Report: ISSUES

Function: Test, Adjust, & Balance

Forge HQ (Kansas City, MO)

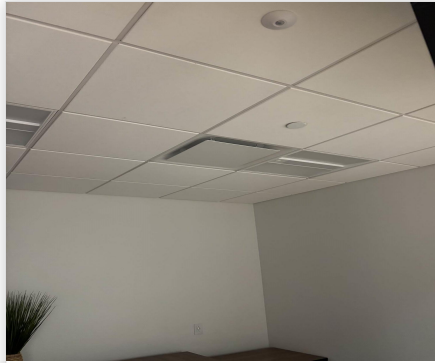
Issue Name : FCU-2: Broken Damper Handle
Description : The damper handle is broken. The handle fell out when the insulation got pulled back. Need new damper installed.
Created By : National TAB **Assigned To :** National TAB - Kalen Kemp
Status : Open
Priority : Urgent **Asset Tag :** F2-2
Originated Date : 09/24/2025 - Kalen Kemp - National TAB

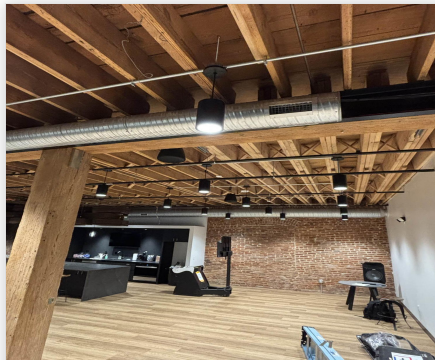
Issue Name : FCU-2: Missing Damper
Description : The damper for the office diffuser is missing. Need installed.
Created By : National TAB **Assigned To :** National TAB - Kalen Kemp
Status : Open
Priority : Urgent **Asset Tag :** F2-9
Originated Date : 09/24/2025 - Kalen Kemp - National TAB
